Design Review Committee Meeting

700 Doug Davis Drive
Hapeville, GA 30354

June 17, 2020 6:00 PM

**DEPARTMENT OF PLANNING AND ZONING
PLANNER'S REPORT**

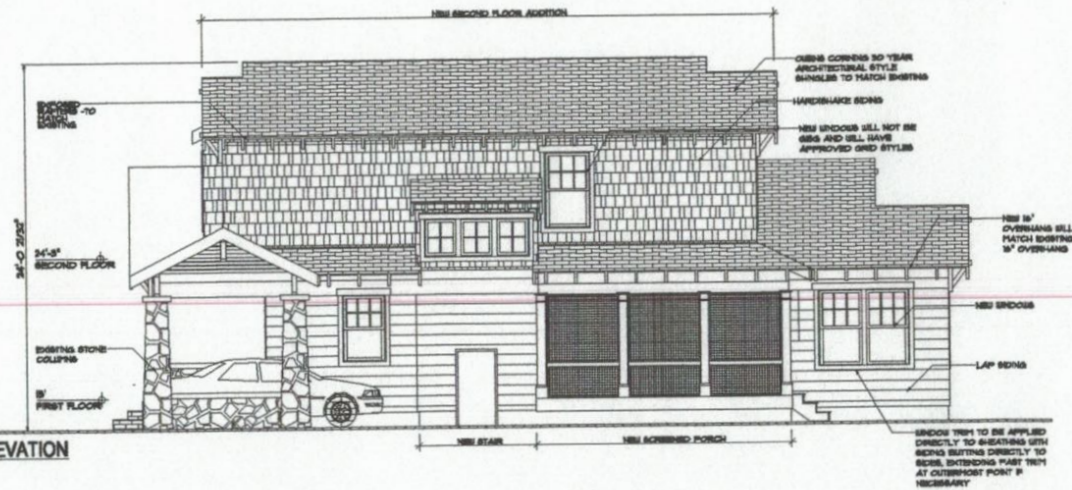
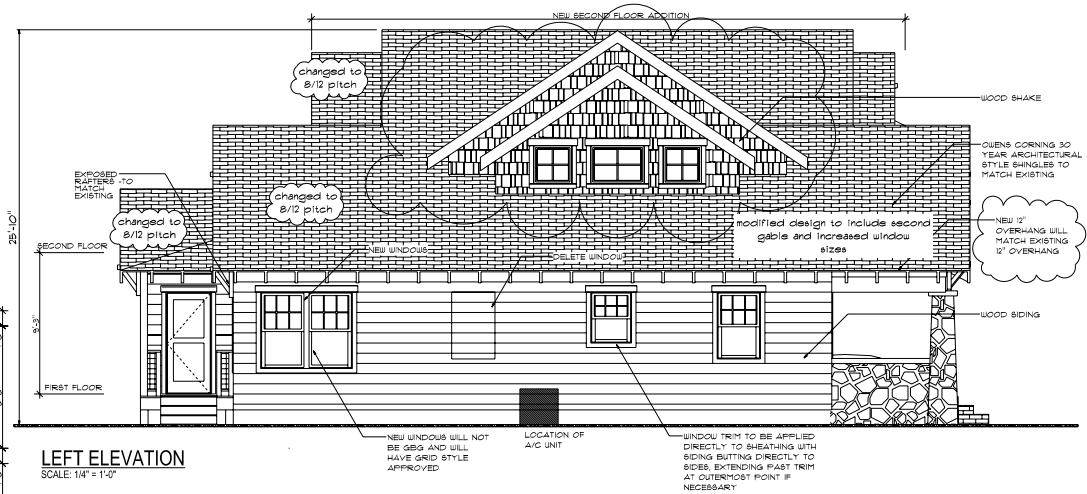
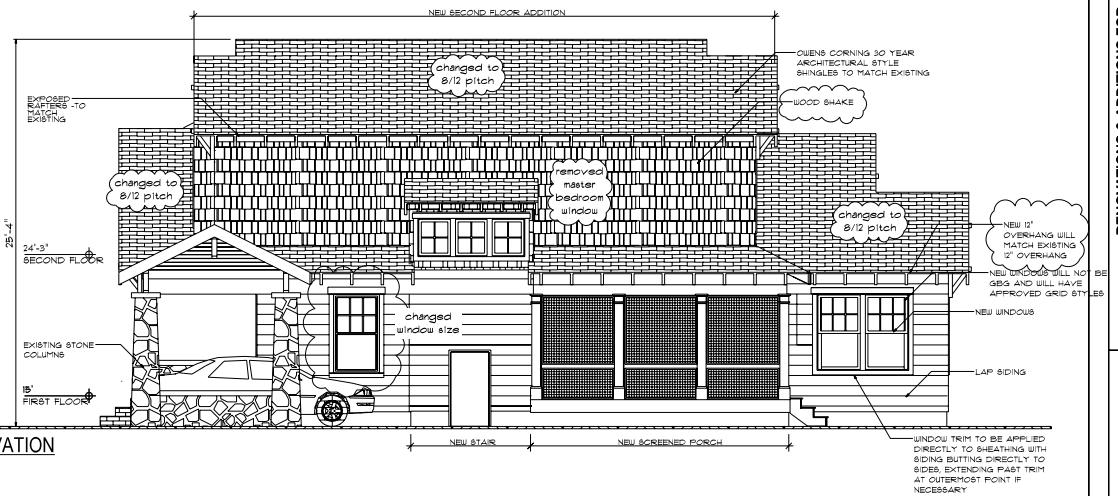
The City of Hapeville has received a revised design from Andy Steele for the following modifications to an approved renovation for an existing one-story single-family dwelling located at 3429 Rainey Avenue. Per the Applicant, the revisions consist of:

- 1) Changed the roof from 6/12 to an 8/12 to provide head room in the master bath and closet to keep from clipping the ceiling
- 2) Removed the 3052 single window on the right side of the house to allow for bedroom furniture
- 3) Changed the window on the first floor in the living room from a 3046 single to a 3052 single to bring in more light
- 4) Added the extra gable on the side to break up the 1 large gable and removed the non functioning louvered vent
- 5) Changed wood window sills to Rot Free PVC (this was a note on the plans we removed)
- 6) Changed hardi shakes to cedar shakes
- 7) The builder did not use a larger mullion between twin and triple windows (builder mistake)
- 8) The builder changed the overhang from 16" to 12" (mistake by builder)
- 9) Modify the second story bathroom window on the side of the house.

Site Plan

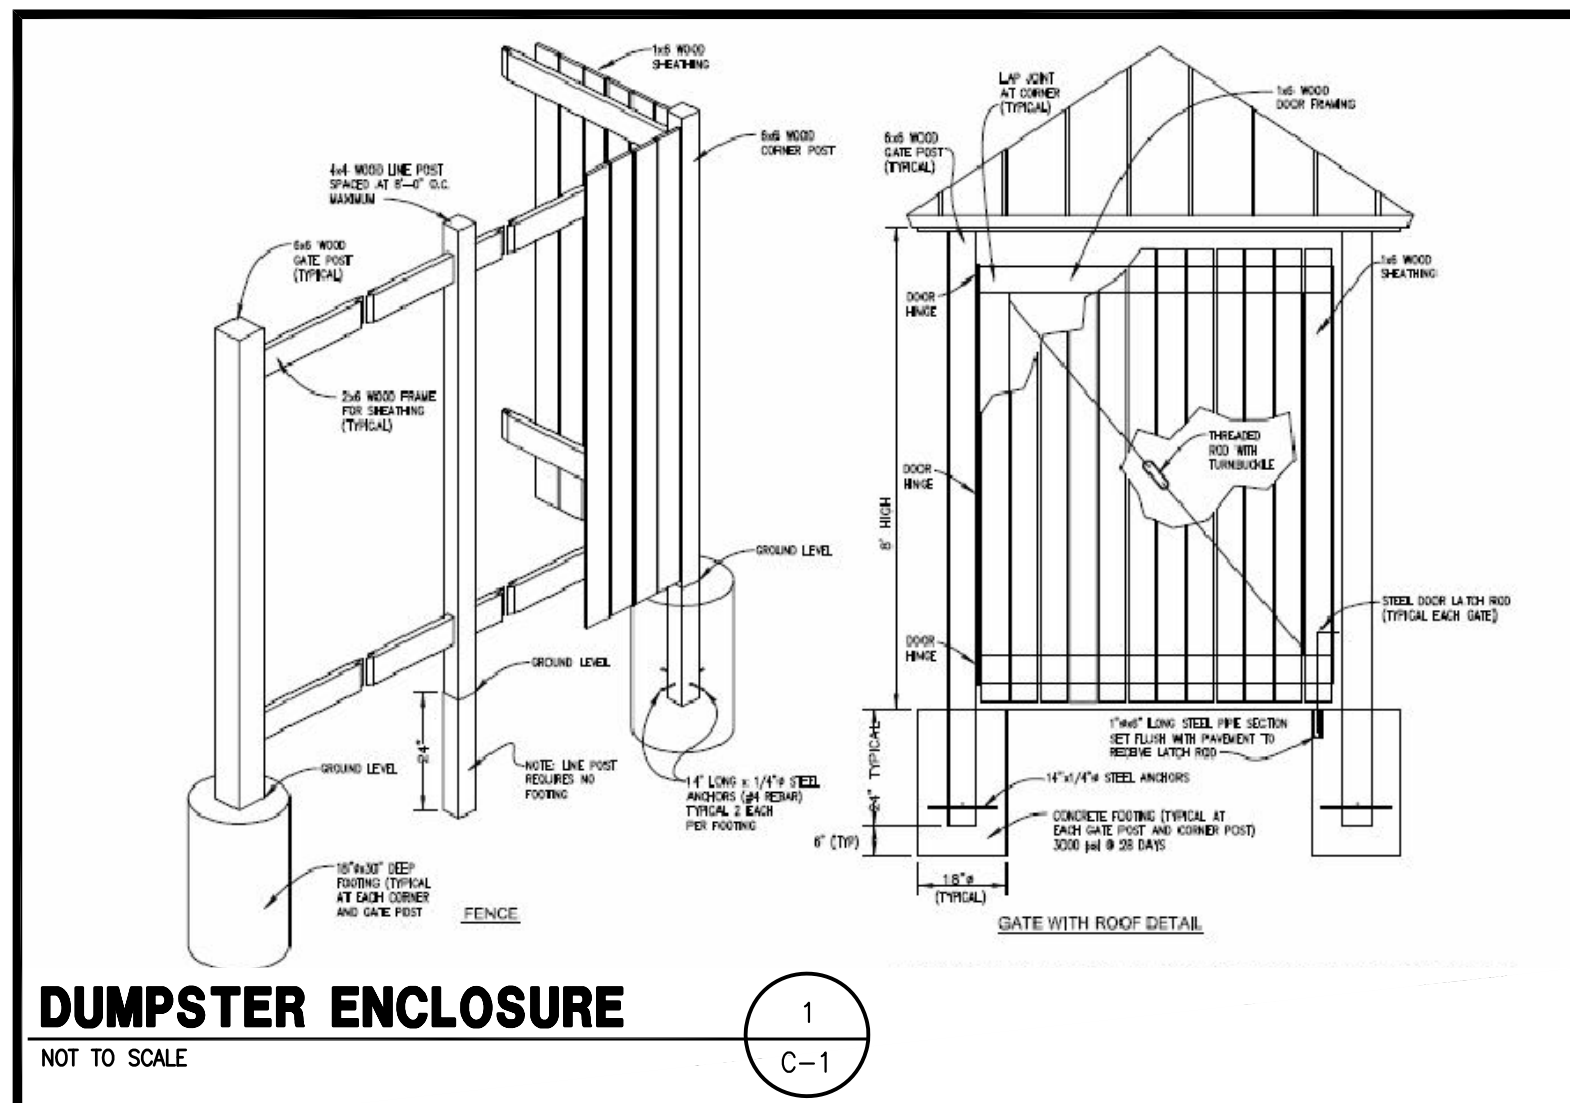
NOTES: The plans must include pedestrian-scale lighting on private property. Recommended lighting along S Central on or along the fence/wall, along Colville adjacent to the restaurant and adjacent to the street and along Willingham with relocated sidewalk to augment existing City lighting.
 Dumpster screening must be compliant and brick walls to match commercial building.

STAFF COMMENT: City Staff and our arborist are working with the Applicant to potentially relocate the western sidewalk along Willingham to the street and not along the upper ridge to possibly save additional landmark trees. The Planning Commission approved the site plan with this condition. Staff would ask the same of the Design Review Committee to allow for further exploration of a street side sidewalk to improve accessibility.

STAFF COMMENT: **Mechanical features must be screened from view.
Pedestrian level lighting should be provided around the perimeter (private property) to support pedestrian friendly design.**

STAFF COMMENT: **The maximum width allowed for a two-way driveway is 24'. The width of the two driveways are 26', which is not compliant, however this width is at the request of the fire marshal and a design exception is recommended.
Parking is shown between S Central and the rear of the townhomes separated by a wall.**

Applicant must show screening for mechanical features.

Applicant should provide pedestrian level lighting along S Central, Colville and Willingham on private property.
